Access Compliance Report

Public Rights-of-Way

(Pedestrian Signals)

Intersection ID: N/A	Main Street:	Cross Street: N/A	Location: N/A
ADA ID: 5274CBD0EE2C	Signal Type: One Push Button-Non APS	Overall Compliance: No	Severity Score: BTN 1: N/A BTN 2: N/A No BTN: N/A
Codes/Mitigation Info/Possible Solution		Field Measurements/Component Compliance

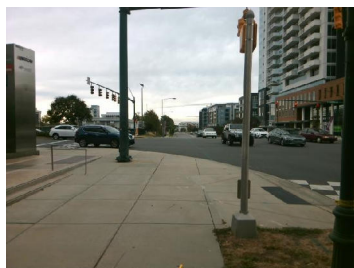
Possible Solutions: Replace Signal Push Button With APS Button on New Post. Remove & Relocate Sign.

PROW/ADA: TMUTCD 4e.08, R406.2
